PRODUCT CHANGE NOTIFICATION

Bourns® Model CW160808 and PM0603 Series High Q Chip Inductors

Marking Removal

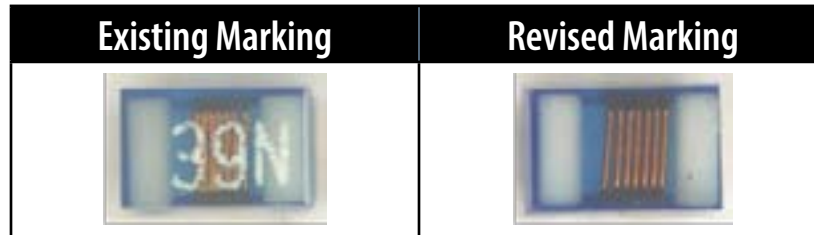
Riverside, California - February 6, 2024 – In the spirit of continuous improvement and environmental awareness, effective March 4, 2024, Bourns will remove the markings for the [Model CW160808](#) and [PM0603](#) High Q Chip Inductors. The affected part numbers are listed below.

As shown in the image above, the form of the affected part numbers will change slightly due to the marking change. The fit, function, quality and reliability of the affected inductors will not change. Traceability will be maintained through lot code and date code.

- Date that manufacturing of existing inductors will cease: **March 4, 2024**
- Date that deliveries of modified inductors will begin: **March 5, 2024**
- First date code using the above changes: **2410**
